R09PF

**SUBJECT: RECALL R09PF INSUFFICIENT TORQUE ON STEERING  
GEAR MOUNTING FASTENERS**

# Steering Gear Bolts

MODELS AFFECTED: 2009 All American Forward Engines and Rear Engines

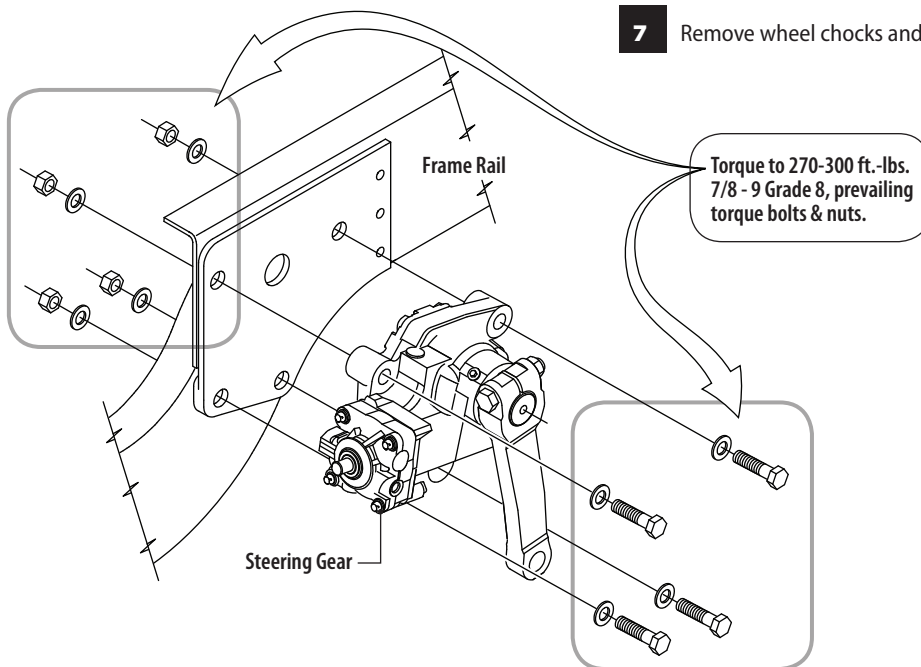
Steering gear mounting bolts may have been incorrectly torqued at installation.

Inspect and re-torque the four bolts that attach the steering gear to the frame rail.

**3** Inspect the bolts and nuts for any damage. If damaged, replace, *DO NOT* re-torque. If damage exist and new fasteners are required, contact:

**4** If no damage exist, re-torque the fasteners to 270-300 ft. lbs. See diagram below.
